**00 91 01      ADDENDUM NUMBER 1**

<b>Project:</b> <u>Carancahua Bay Boat Ramp</u>	<b>Project Number:</b> <u>22-07</u>
<b>Owner:</b> <u>Jackson County</u>	
<b>Designer:</b> <u>Nicholas A. Cecava, P.E.</u>	<u>Freese and Nichols, Inc.</u>
<b>Addendum No.</b> <u>1</u> <b>Specification Section:</b> <u>00 91 01</u> <b>Issue Date:</b> <u>June 24, 2022</u>	
<b>Acknowledge receipt of this Addendum in Section 00 41 13 Bid Form submitted for this Project. Failure to acknowledge receipt of this addendum in the Bid Form may render the Bid as non-responsive and serve as the basis for rejecting the Bid.</b>	
Approved by:	
<u>Nicholas A. Cecava, P.E.</u>	<u>June 24, 2022</u>
<i>Name</i>	<i>Date</i>
Addendum Items:  <b><u>Article 1:</u></b> - Bidding Requirements – <b>(Attachment No. 1)</b>  <b><u>Article 2:</u></b> - Modifications to the Specifications – None  <b><u>Article 3:</u></b> - Modifications to the Drawings – <b>(Attachment No. 2)</b>  <b><u>Article 4:</u></b> - Clarifications – CivCast Questions and Answers

JACKSON COUNTY, TEXAS  
**CARANCAHUA BAY BOAT RAMP**  
 CIVIL  
**SHEET PILE BULKHEAD IMPROVEMENTS**

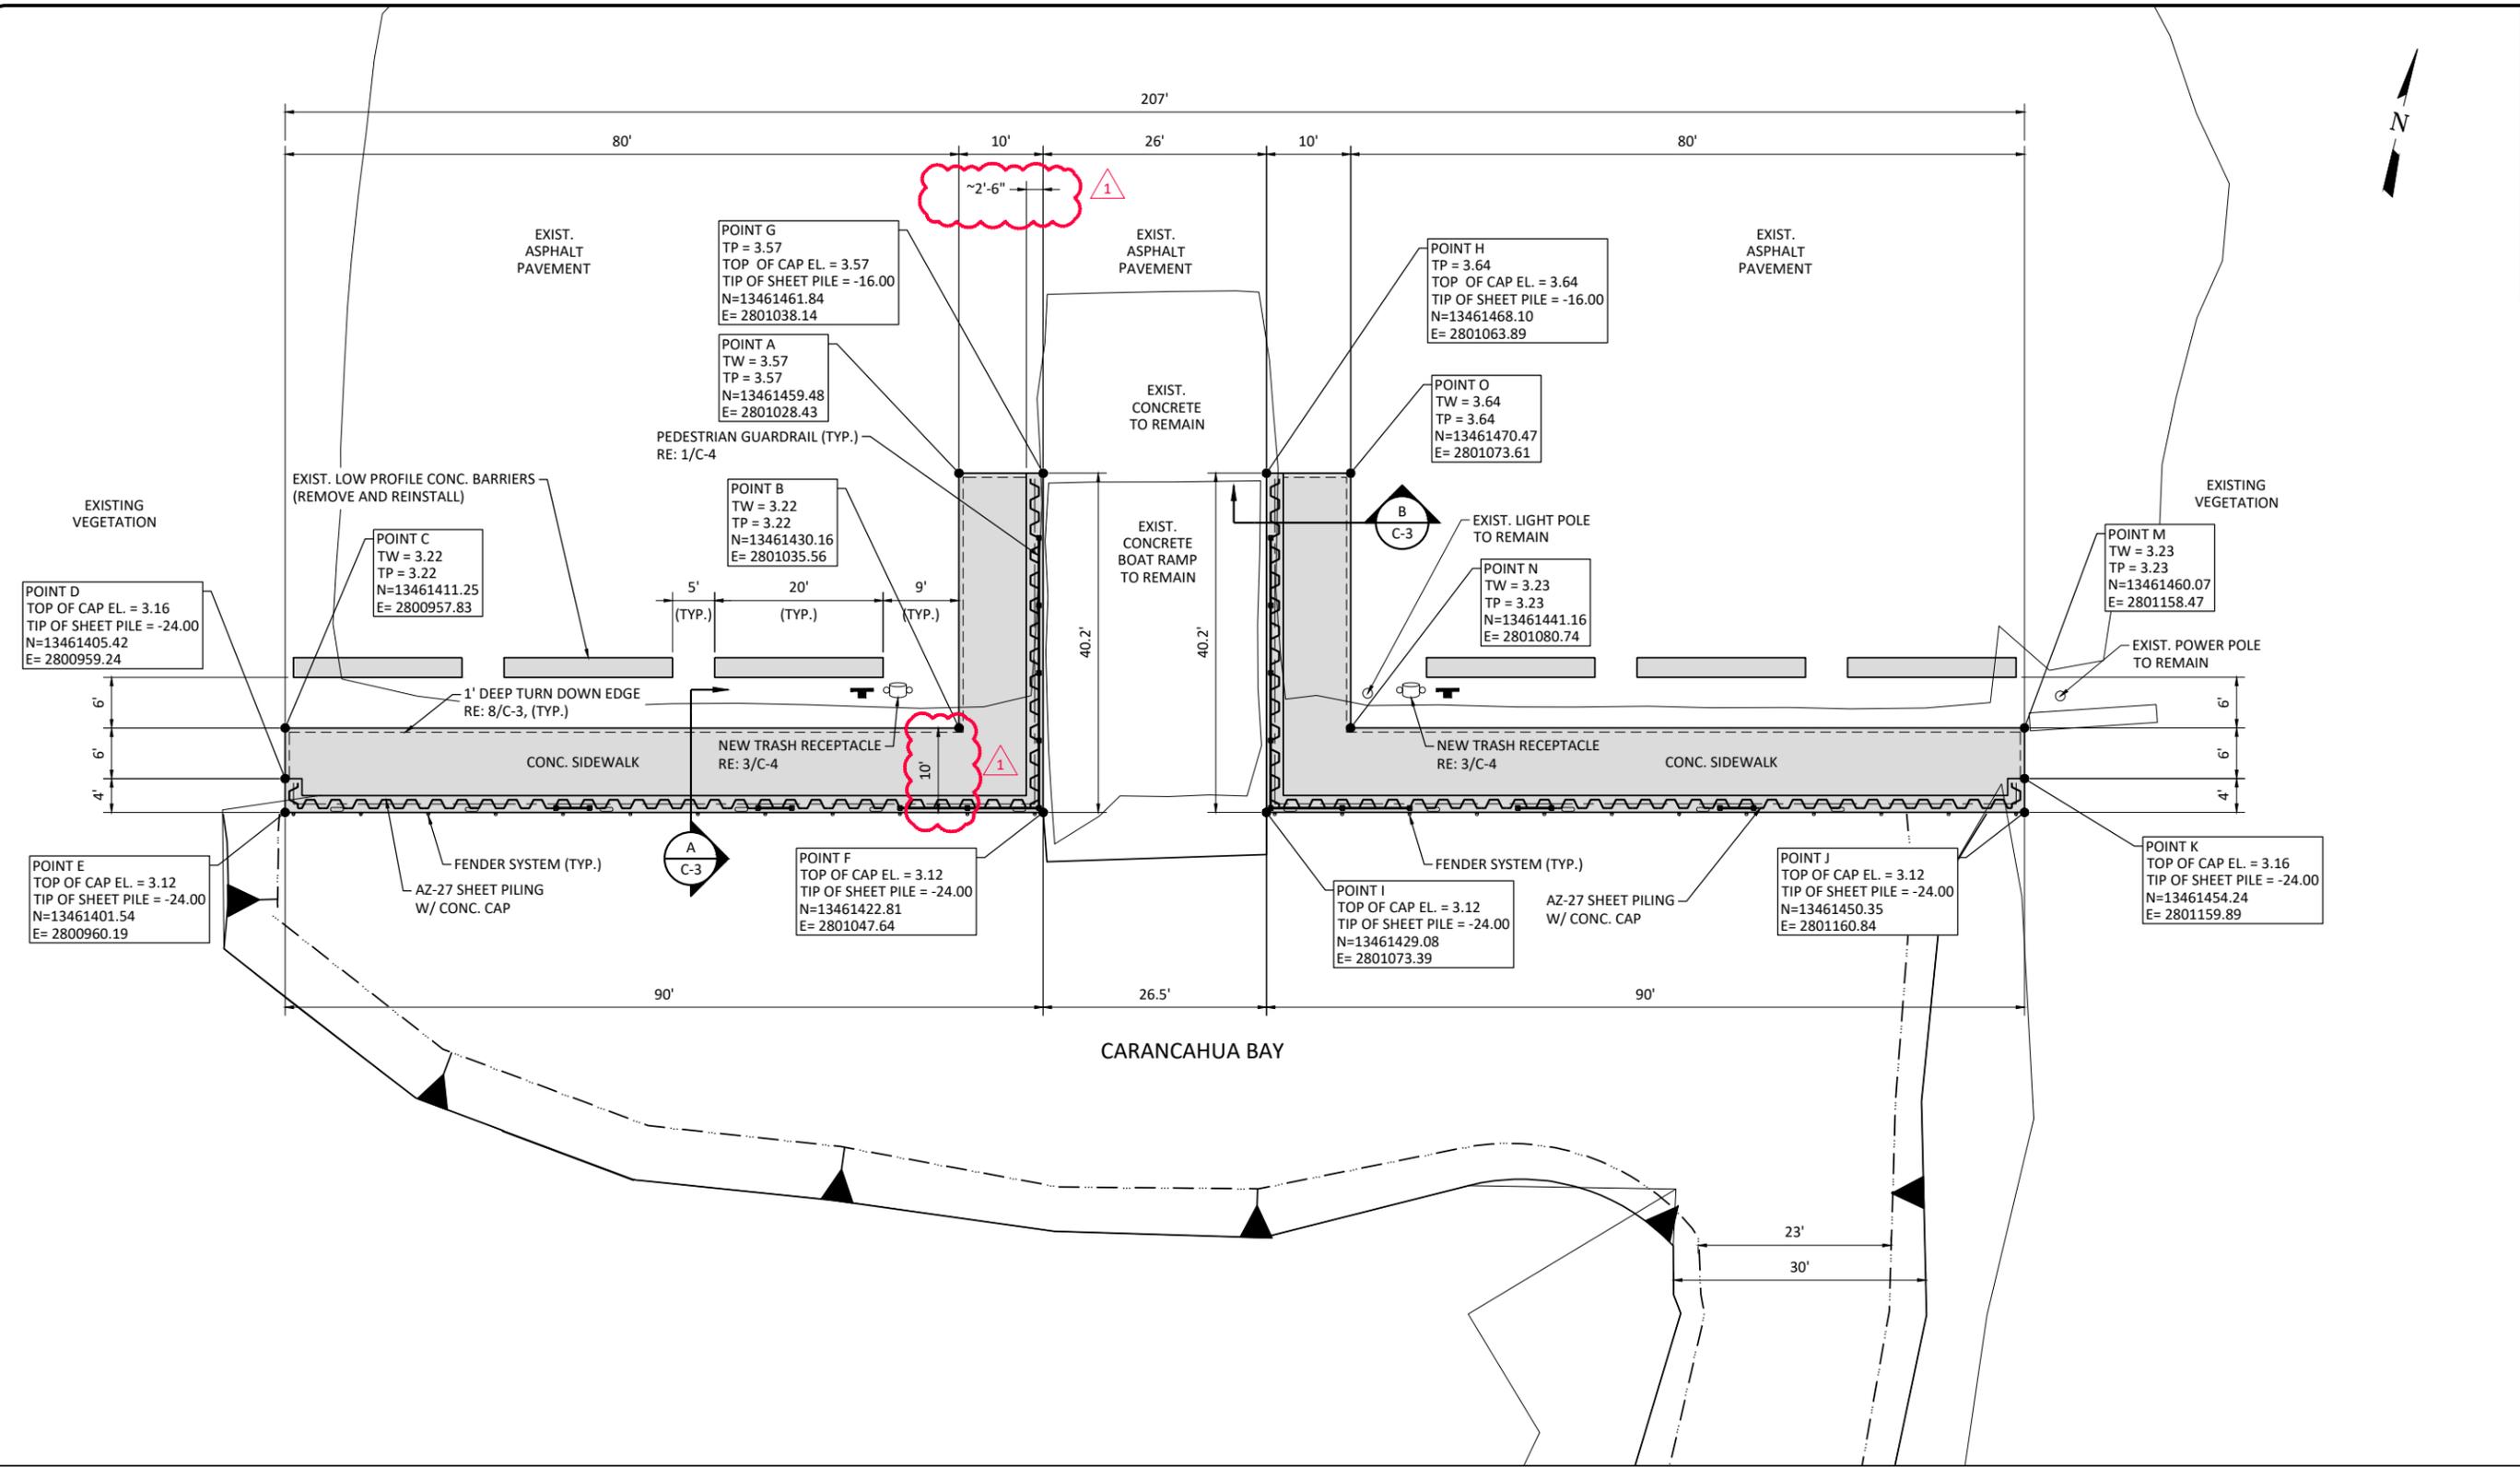
1. Question: How long are the AZ-27 sheet piling?

**Answer: Please refer to the sheet pile and cap elevations on Sheet C-2 and the typical section details on Sheet C-3**
